**Economic and Social Council**

**Recommendations on Harmonized Europe-Wide  
Technical Requirements for Inland Navigation Vessels  
(Resolution No. 61, revised)****Amendment proposals to Chapter 4 “Safety clearance,  
freeboard and draught marks”****Transmitted by the Group of Volunteer Experts on Resolution No. 61<sup>1</sup>****I. Mandate**

## II. Draft amendment proposal for Chapter 4, “Safety clearance, freeboard and draught marks”

Figure 4-3.7 Measurement/draught scale

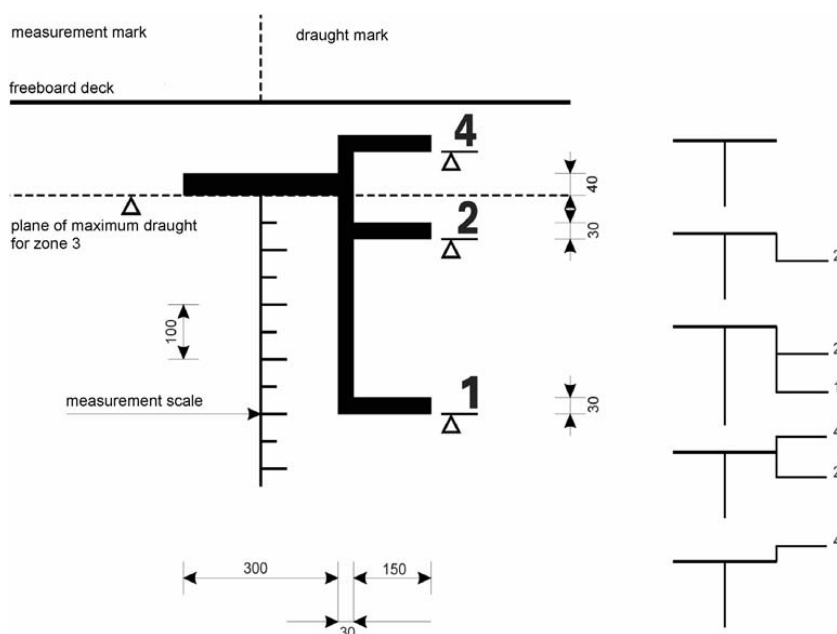
4-3.7 For vessels operating on zones of inland waterways other than Zone 3 (Zones 1, 2 or 4)<sup>8</sup> the bow and stern pairs of draught marks provided for in 4.3.3 shall be supplemented by adding a vertical line to which one or, in the case of several zones, several additional draught lines 150 mm long shall be affixed towards the bow, in relation to the draught mark for Zone 3.<sup>9</sup>

This vertical line and the horizontal line shall be 30 mm thick. In addition to the draught mark towards the bow of the vessel, the relevant zone numbers shall be indicated in lettering 60 mm high × 40 mm deep (see Figure 4-3.7).<sup>10</sup>

The lower edge of each ~~freeboard~~ draught line shall correspond to the ~~freeboard~~ prescribed plane of maximum authorised draught for the navigation zone concerned.<sup>11</sup>

**Figure 4-3.8 Freeboard mark**

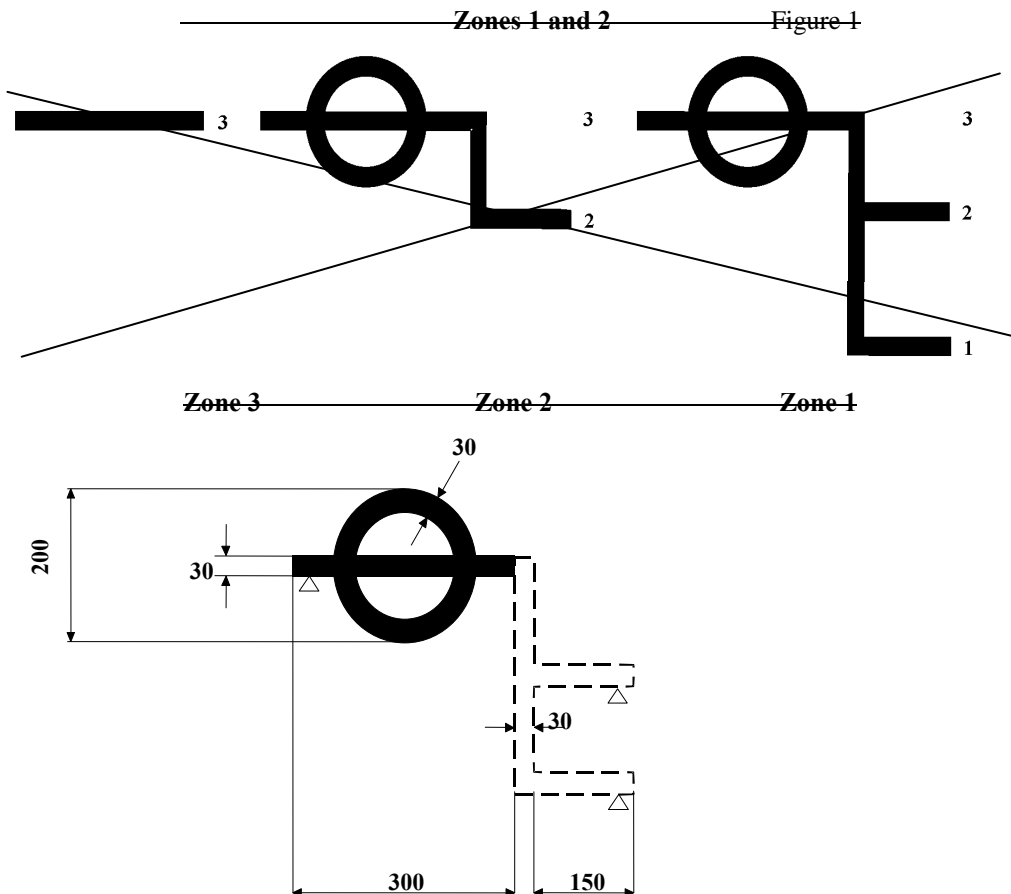
The freeboard mark for zones 1 and 2 shall consist of a ring intersected through its centre by a horizontal line which shall be supplemented if necessary by additional freeboard lines.

The width of the ring and of all the other lines of the freeboard mark shall be 30 mm; the outer diameter of the ring shall be 200 mm; the length of the horizontal line intersecting the ring shall be 300 mm; and the size of the numerals designating the zones shall be 60 x 40 mm (Figure 4-3.8).

The centre of the ring shall be placed amidships. The lower edge of the horizontal line which intersects the ring shall pass through the centre of the ring and shall constitute the freeboard line.

If the vessel is intended to navigate in several navigation zones, a vertical line and additional freeboard lines 150 mm in length shall be applied forward of the centre of the ring.

The lower edge of each freeboard line shall correspond to the freeboard prescribed for the navigation zone concerned.<sup>12</sup>

Figure 4-3.9

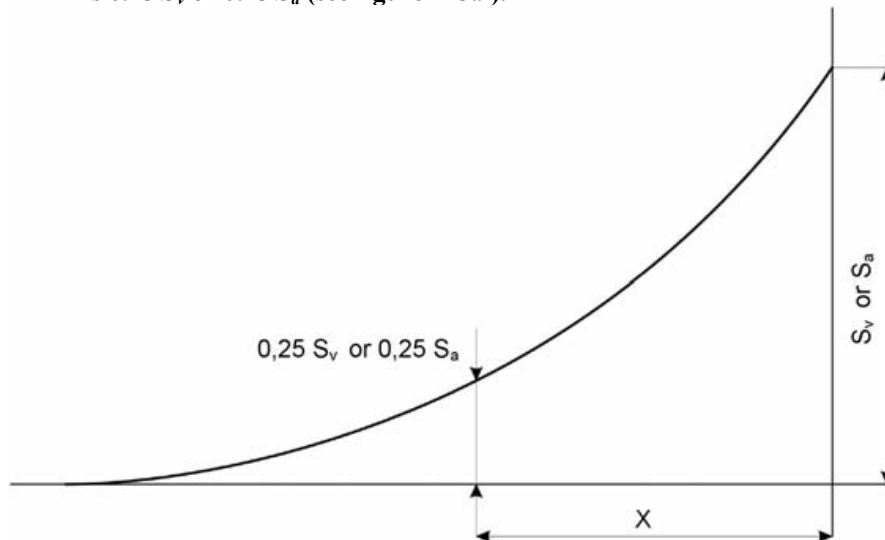
$x$  is the abscissa, measured from the extremity of the point where the shear is  $0.25 S_v$  or  $0.25 S_a$  (see figure 4-3.9).

However, coefficient  $p$  will not be taken to be more than 1.<sup>18</sup>
